CONDITIONAL USE PERMIT PLAN Attachment A MOUNTAIN VALE COMMUNITY SOLAR

17700 BARNESVILLE ROAD BARNESVILLE, MARYLAND 20838

SUBJECT: Mountain Vale Community Solar Project, CU #202507

RE: Conditional Use No. CU202507 11700 Barnesville Road Mountain Vale Solar

SHEET 6 OF 19

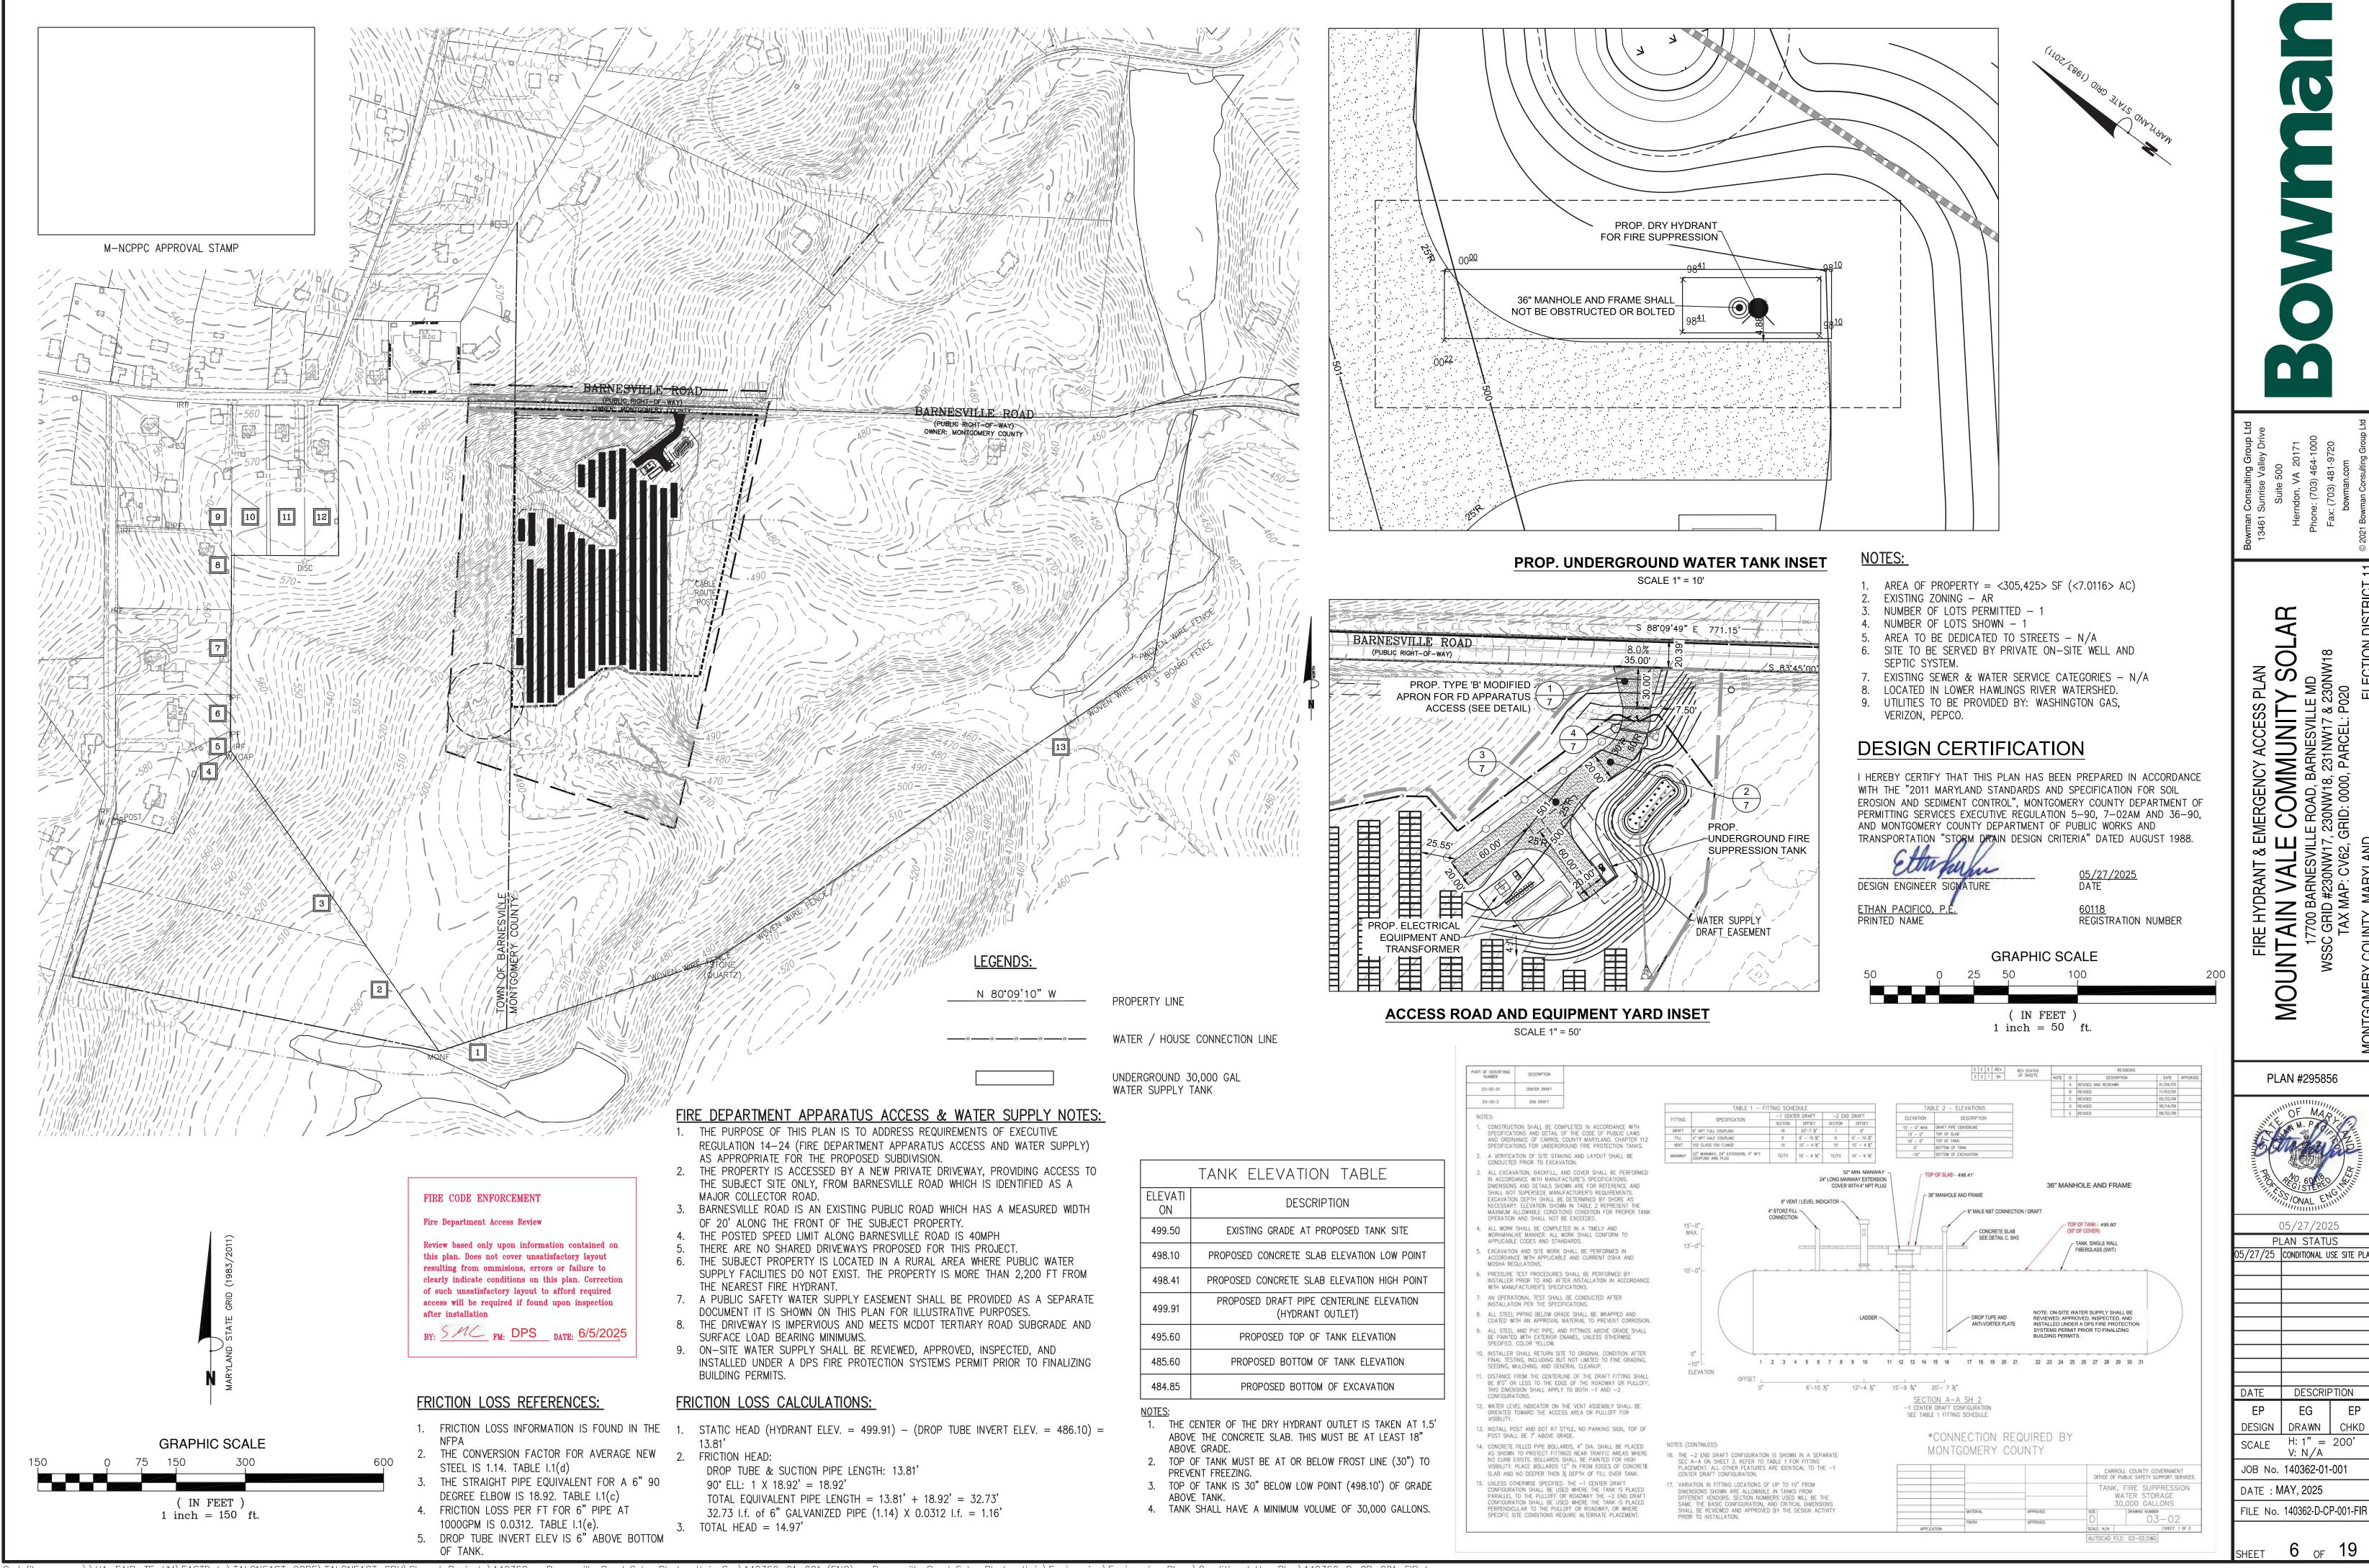
*** Cistern installation required ***

*** 6/5/2025 CU202507 - Fire department access plan is sheets 6-7 of 19 sheet CU202507 plan set. This approval does not review and is not relevant to pages 1-5 or 8-19. ***
